Transmission Expansion Advisory Committee – PPL Supplemental Projects

Scope Change s0867

Supplemental Number: S0867

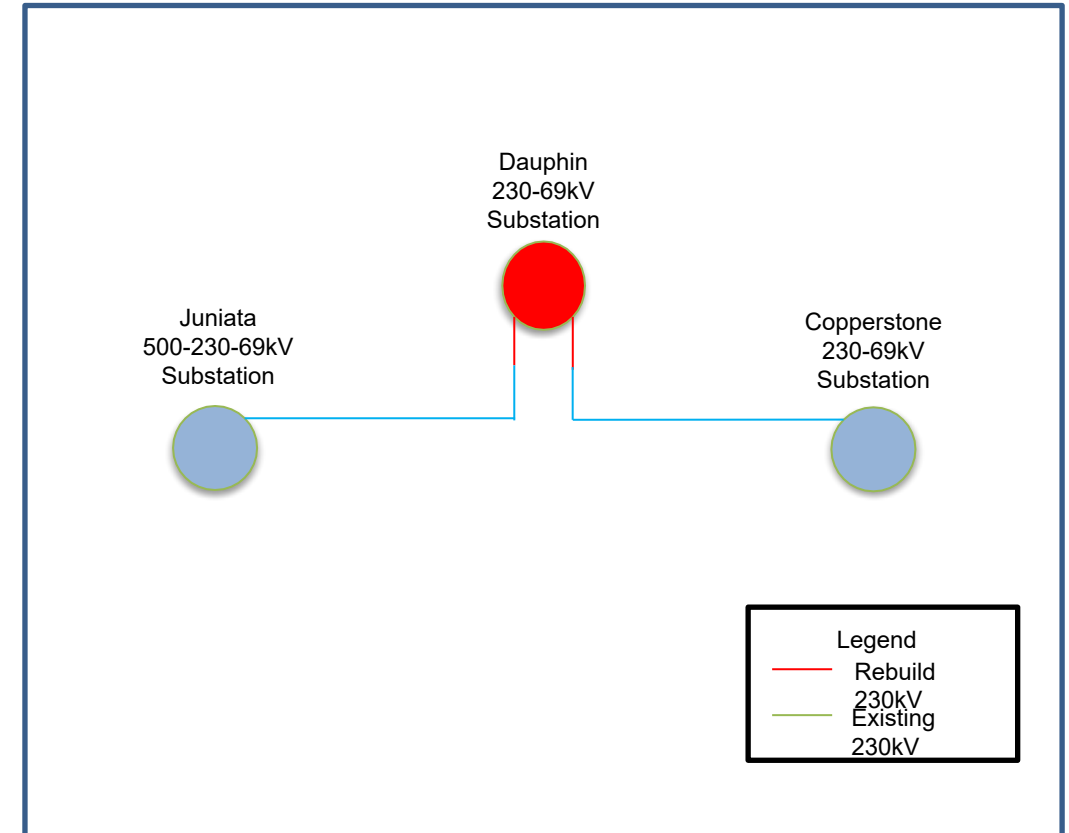
- **Proposed Solution Addition:**

First Energy owns the transmission lines into the PPL owned Dauphin substation. PPL and FE are moving the demarcation point to a tower ~0.1 miles outside the substation. FE to replace tower 1087-3 with new steel pole dead-end structure.
